## ORIGINATION FORM

Proposed Revisions to a Standard Plans Index  
(Please provide all information — Incomplete forms will be returned)

Index Number: 700-102  
Sheet Number (s): 5,10,11,12  
Index Title: Special Sign Details

Update existing signs and add new signs to the special sign details index. Update MOT signs to current MUTCD standards; Added a new MOT 'BIKES MERGE' sign with arrow sign; Update 'SPEEDING FINES DOUBLED' sign to current MUTCD standards and correct ftp graphic; Add two new school bus load or unload signs.

**FTP-38-06**  
 2' X 2'-6"  
 4" Radii 3/4" Border  
 3" Series D Legend  
 White Background  
 Black Legend and Border

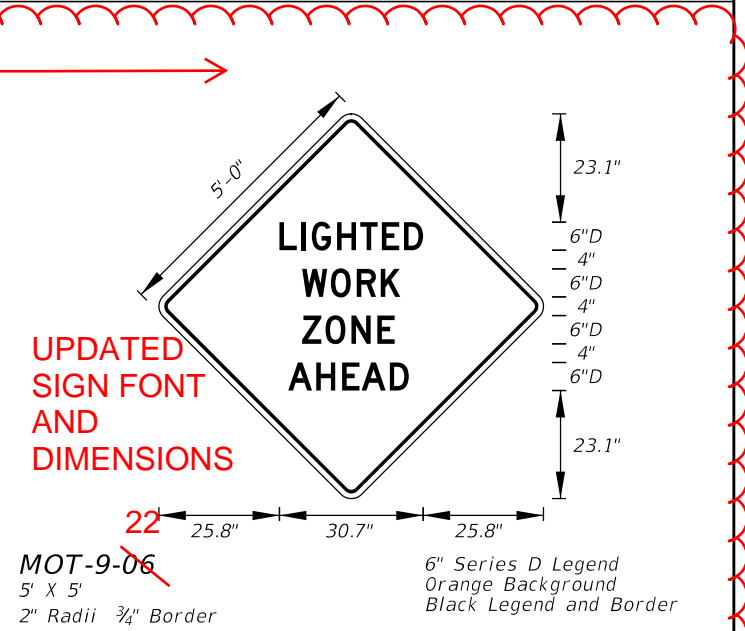
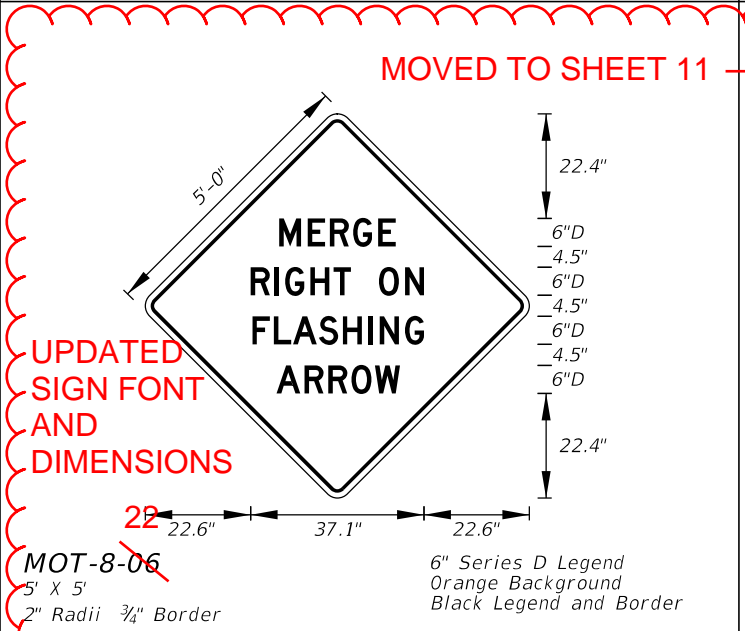
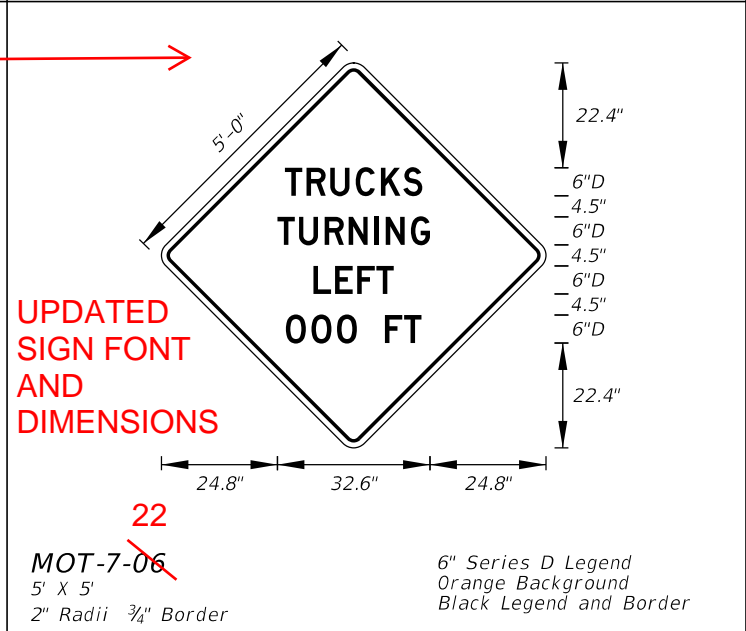
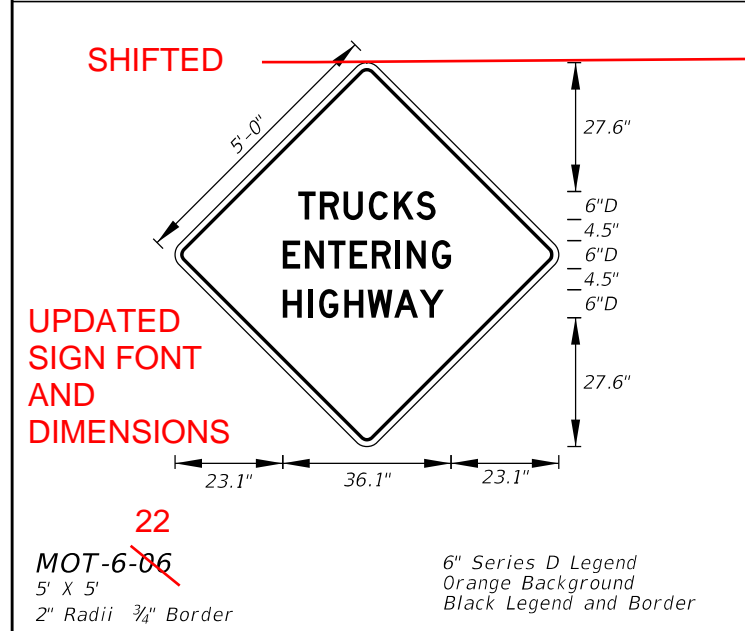
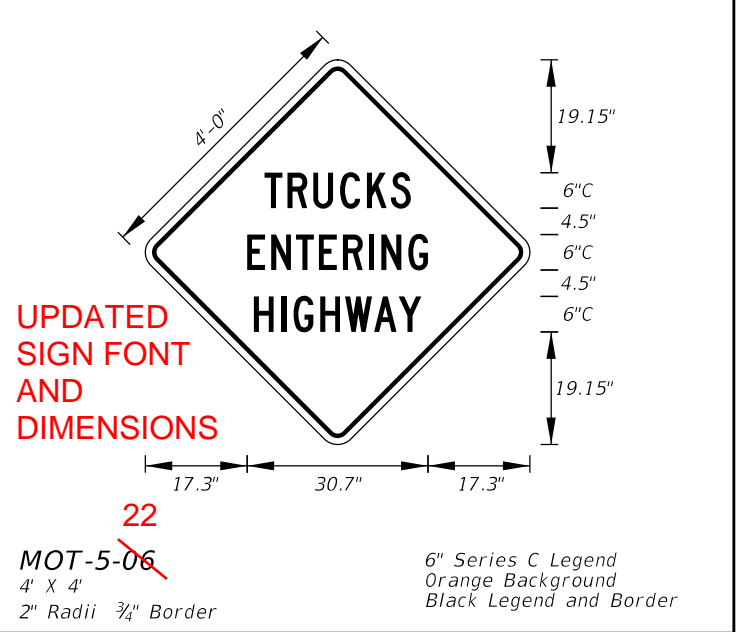
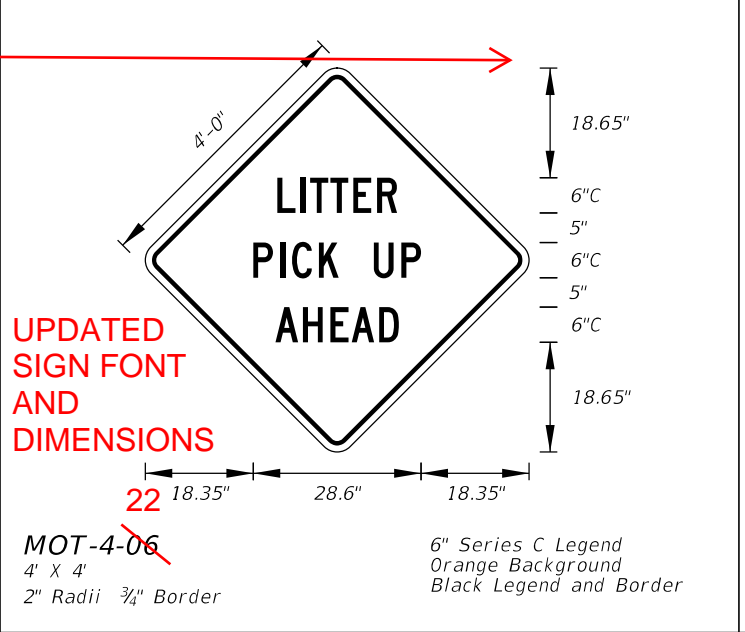
Sheet 5: Updated FTP-38-06 font, dimension, and numbering.

UPDATED SIGN FONT AND DIMENSIONS

**FTP-38-22**  
 2' X 2'-6"  
 1.5" Radii 1/2" Border  
 4" Series C Legend 80% Spacing  
 White Background  
 Black Legend and Border

**FTP-90-22**  
3'-0" X 3'-0"  
1.5" Radii 3/4" Border  
3" Series C Legend and 5" Series D Legend  
White Background  
Black Legend and Border

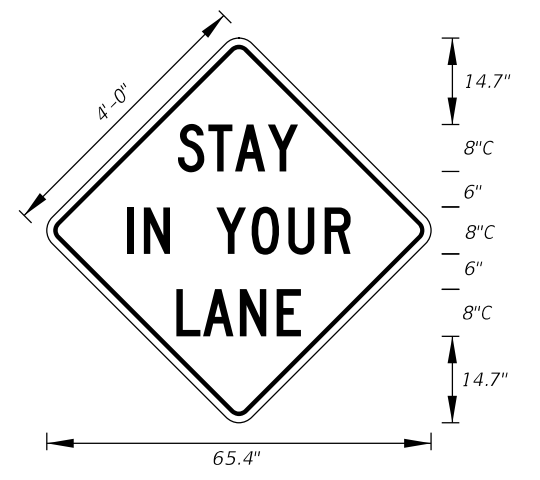
Sheet 10: Added FTP-90-22 and FTP-91-22; Updated MOT-1-06, MOT-4-06, MOT-5-06, MOT-6-06, MOT-7-06, MOT-8-06, and MOT-9-06 font size, dimension, and numbering; Shifted to accommodate new signs; Moved MOT-8-06 (MOT-8-22) and MOT-9-06 (MOT-9-22) to Sheet 11.

**MOT-10-22**  
4' X 4'  
3" Radii 3/4" Border  
7" Series C Legend  
Orange Background  
Black Legend and Border

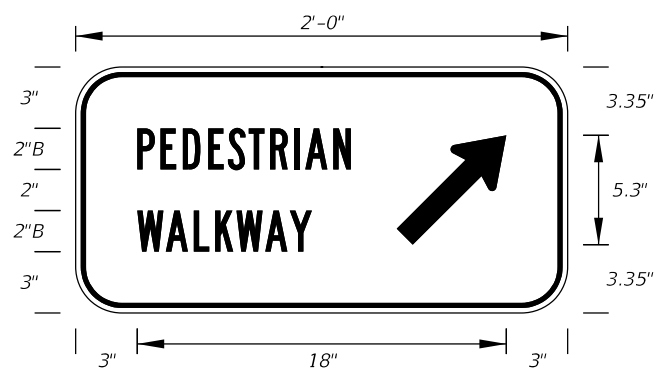
Sheet 11: Updated MOT-10-06 font size, dimension, and numbering; Shifted to accommodate new signs; Moved G20-1 and G20-2 to Sheet 12.
